PIC16C773

PIC16C773 Rev. B Silicon Errata Sheet

The PIC16C773 (Rev. B) parts you have received conform functionally to the Device Data Sheet (DS30275A), except for the anomalies described below.

FIGURE 15-1: PIC16C773/774 VOLTAGE-FREQUENCY GRAPH, $-40^{\circ}\text{C} \leq T_A \leq +85^{\circ}\text{C}$

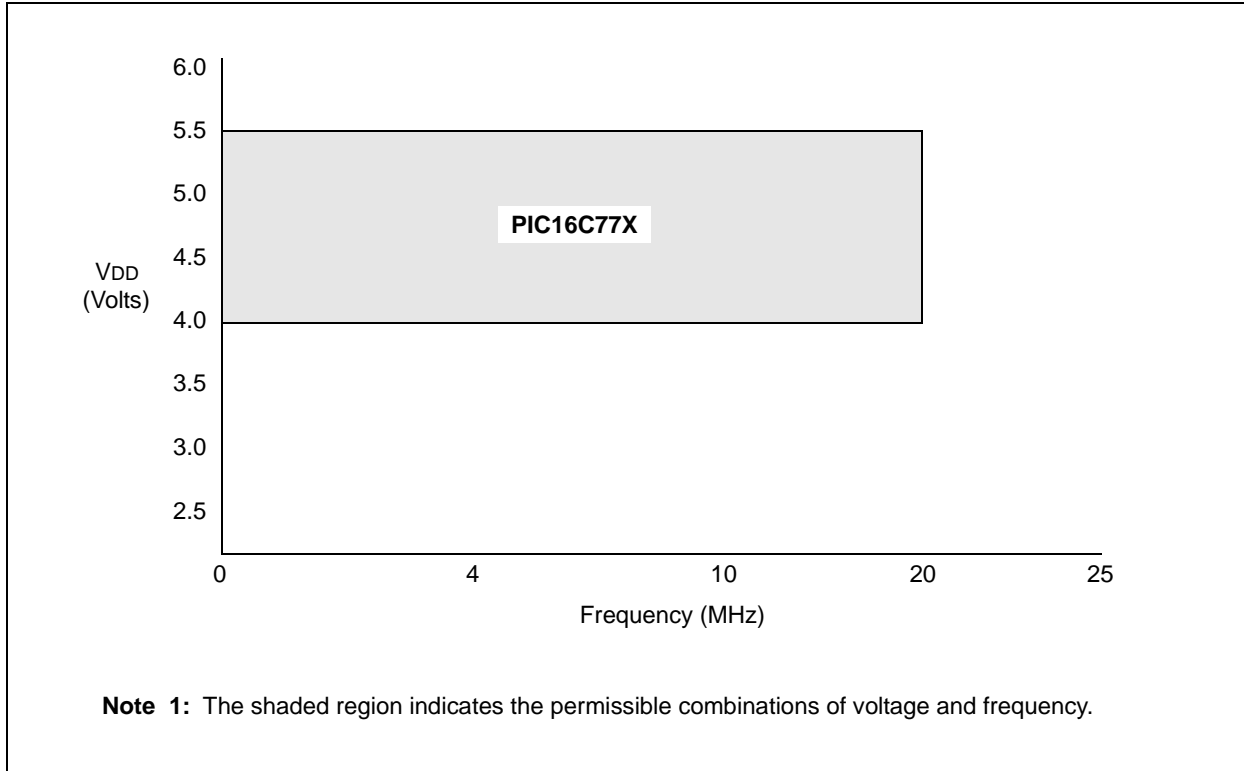
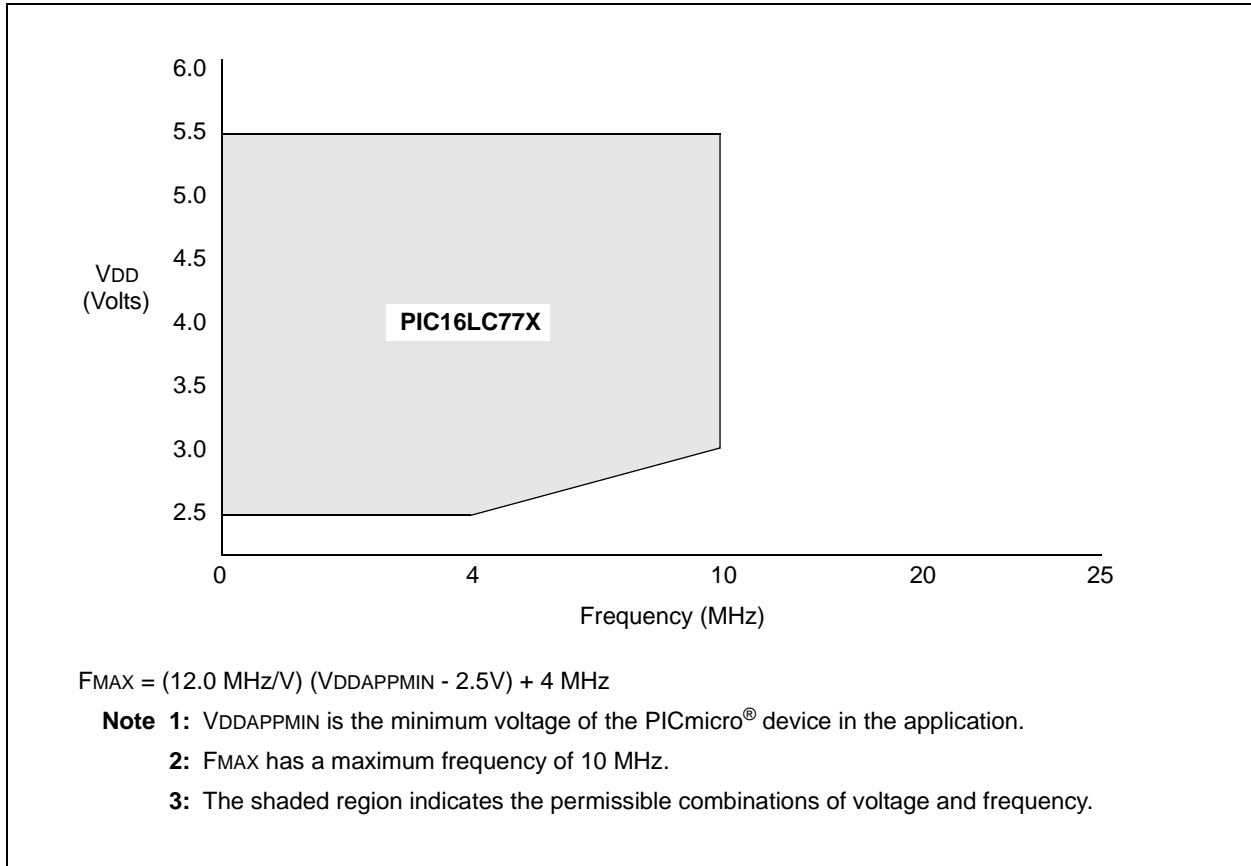
1. Table 15-1 in the Device Data Sheet (DS30275A) should be omitted. Figure 15-1 and Figure 15-2 below should be used to determine the operating voltages and frequencies for the devices.

FIGURE 1: A/D CLOCK SOURCE BLOCK DIAGRAM

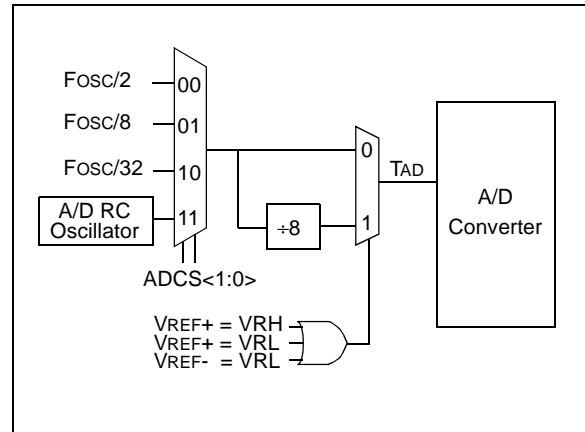
8. The A/D clock source bits (ADCS1:ADCS0) have had their operation modified. See Register 1 for a new definition of the ADCS1 and ADCS0 bits.

Figure 1 shows how the TAD time is determined based upon the selection of the ADCS<1:0> bits and the source of VREF+ and VREF-. When VREF+ or VREF- comes from the internal voltage reference (VRH or VRL), then the required TAD time is increased by a factor of eight (see electrical specification parameter #130A).

The clock source selected by the ADCS<1:0> bits is divided by eight when an internally generated reference voltage is used as reference to the A/D module. This automatically addresses the requirement for the TAD time when the internal voltage reference is used as the A/D voltage reference.
